From: Crawford, Amanda L. <ALCrawford@Venable.com>
Sent: Thursday, March 05, 2020 11:49 AM
To: Read, Brent <Brent.Read@icf.com>
Cc: Floyd, Kathryn K. <KKFloyd@Venable.com>; Michael@jonesanddemille.com; Keller, Kevin <Kevin.Keller@hdrinc.com>; Brian Barton <Brian@jonesanddemille.com>; coalition_UBRY@jonesanddemille.com; Rogers, Debra <Debra.Rogers@icf.com>; Moelter, Chris <Chris.Moelter@icf.com>
Subject: RE: Grate-Separated Road Crossings/Bridges

Subject: Grate-Separated Road Crossings/Bridges

Question 1a.

Figure 1 BLM encroachment is circled in red

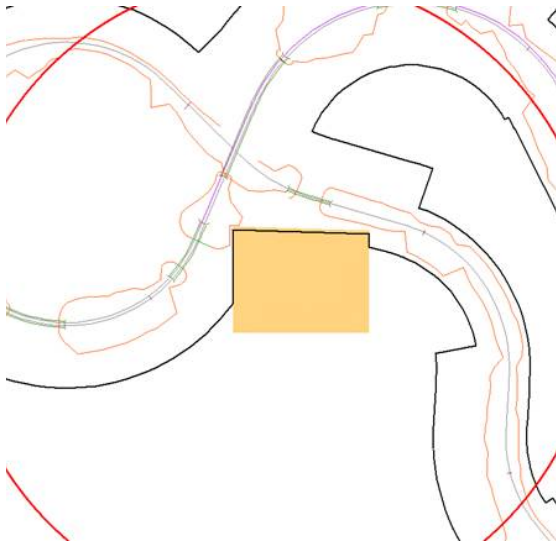
The new Whitmore Park alternative appears to cross BLM land in 4 locations (see screenshot). These are small slivers, but I wanted to discuss possible ways to deal with these issues. Thoughts I have had:

Response: Please see the attached email from Travis Tzoumis, dated February 13, 2020. The reason the new Whitmore Park alternative appears to cross BLM-managed land in these areas is because the data is being projected onto the wrong coordinate system. The data should be projected into the Utah State Plan Central-US Foot coordinate system. When all of the data is projected into the same, correct coordinate system, the results show that the final Whitmore Park alternative does not cross BLM-managed land.

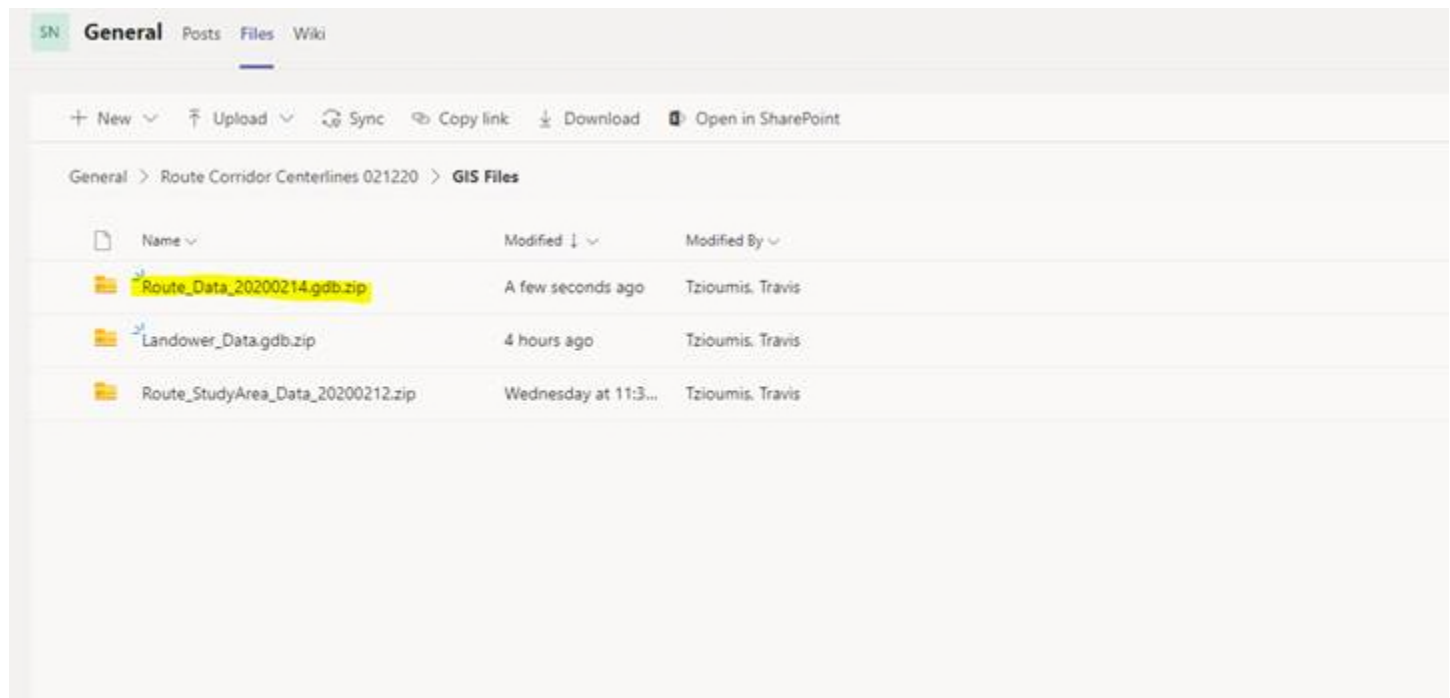
Regarding communication towers: Can I assume a steel lattice tower, which will be more visible than a single pole?

Response: Communications towers for the project are anticipated to look similar to the tower depicted in the image below. These towers will be more visible than a single pole but are not as wide as steel lattice towers typically utilized for high voltage transmission lines.
